TMC SPECIFICATION NO. S - 830

TITLE: KIT-184 HFR-1 OVEN MODIFICATION

The purpose of this modification is to provide an over-temperature protective feature in the proportionally controlled HFO oven assembly of the Model HFR-1 (TM-376/UR) to prevent overheating in the event of failure of the proportional control unit, TMC Part No. PO-240. A front panel over temperature indicator is also provided.

TITLE: FIGURE 1 HFR-1 FRONT PANEL

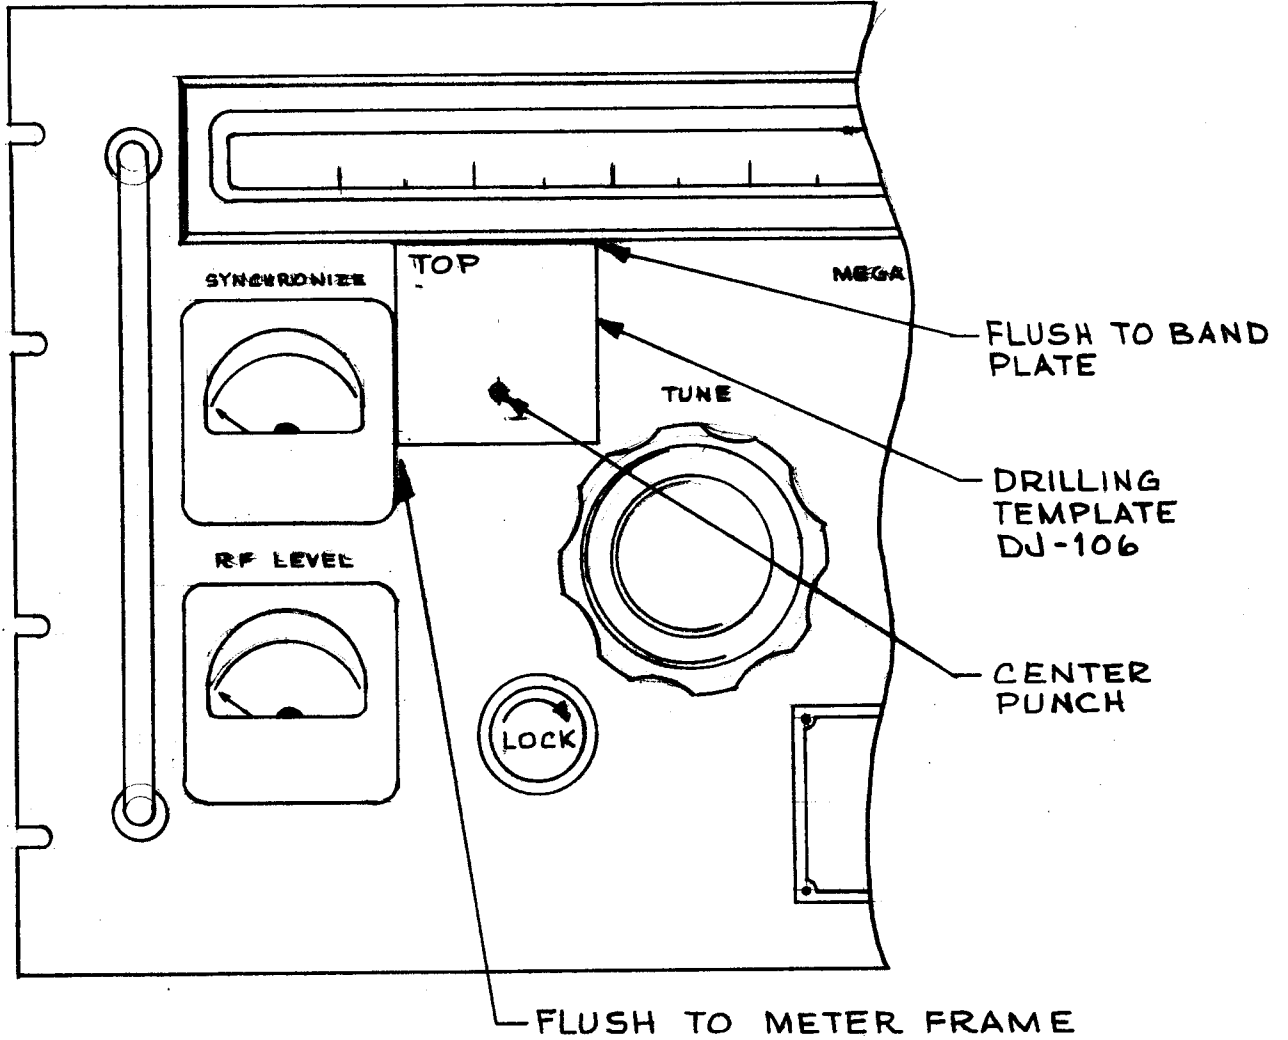
1. Place drilling template on front panel, holding it firmly against the synchronized meter and the band scale frame, Make sure that the edge marked "TOP" is against the bandscale frame.
2. Mark the panel through the hole of the template using a center punch.
3. Remove template and drill a 15/32" diameter hole. (It is suggested that a small hole be drilled first then gradually increased until the 15/32" diameter is obtained.)
4. Insert the OVEN OVERHEAT INDICATOR through the identification plate and then through the panel. Apply lockwasher and nut and tighten.
5. Proceed with instructions for Figure 2.

TITLE: FIGURE 2 HFR-1 FRONT PANEL

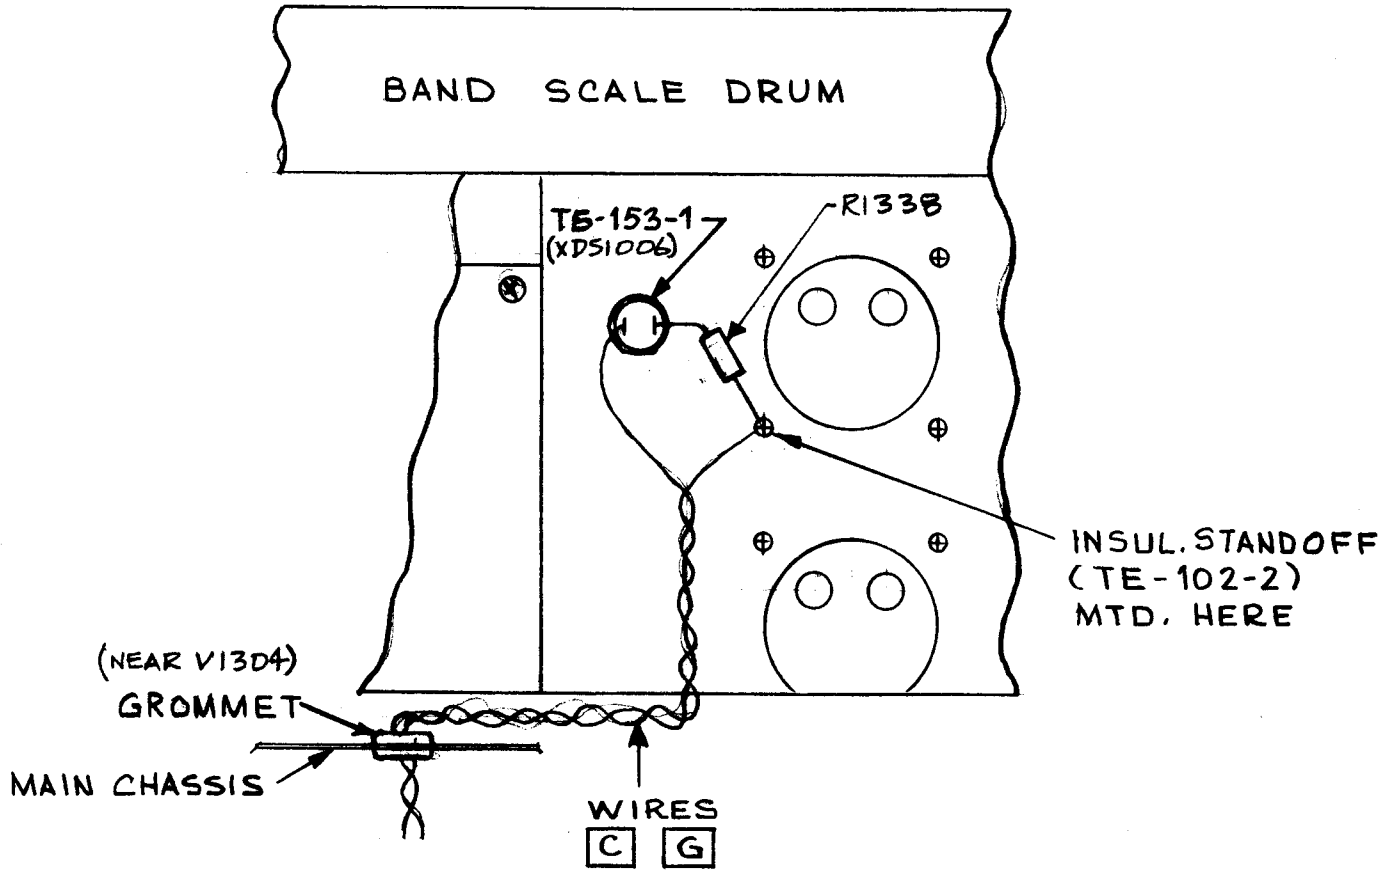
1. Mount the KIT supplied insulated standoff (TE-102-2) on the lower inside screw of the top meter.
2. Solder the KIT supplied resistor (RC42GF2210) between the insulated stand-off and the closest terminal on the OVEN OVERHEAT indicator.
3. Proceed with instructions for Figure 3.

14. Lay wire "G" along side of main cable trunk toward front of unit, then through grommet located near tube socket XV-1304. (SEE FIG. 2)
15. Tie wire "G" to main cable with lacing cord in as many places as practical.

16. Twist wires "C" and "G" to within 2 inches of ends. (SEE FIG. 2)
17. Solder the shorter of the two wires to the insulated standoff which was mounted on the meter mounting hardward in Step 1 of Figure 2.
18. Solder the longer wire to the open terminal of the oven overheat indicator.
19. Recheck all previous steps to insure proper installation.
20. Shake unit out to insure that no loose hardware is left in oven.
21. Replace outer top cover of oscillator oven.
22. Replace top and bottom covers of unit.
23. Reconnect power plug to J-1305 at rear of unit.

TITLE:      FIGURE 3      DISASSEMBLY

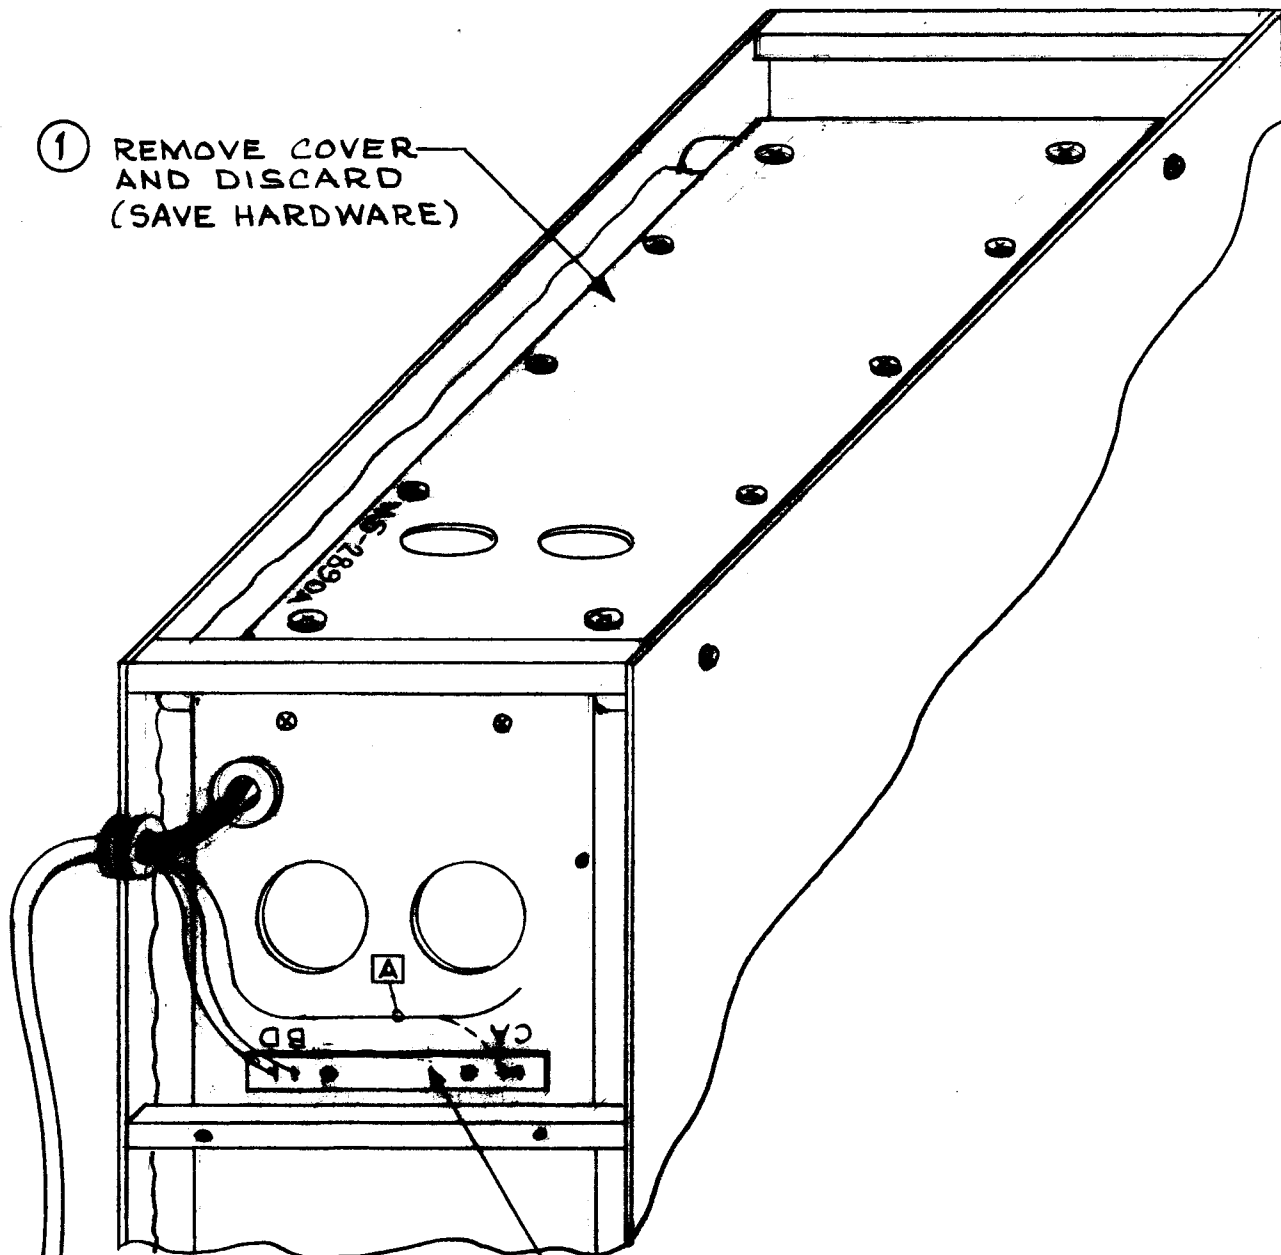
1. Remove inner top cover of oscillator oven (MS-2890) and discard.
2. Unsolder red wire from terminal "C & A" (located on left side of oven) and affix wire marker "A" to this wire. Do not remove "C & A" jumper.
3. Proceed with instructions for Figure 4.

① REMOVE COVER AND DISCARD (SAVE HARDWARE)

② REMOVE RED WIRE FROM TERMINAL C AND A AND APPLY WIRE MARKER "A" TO WIRE.
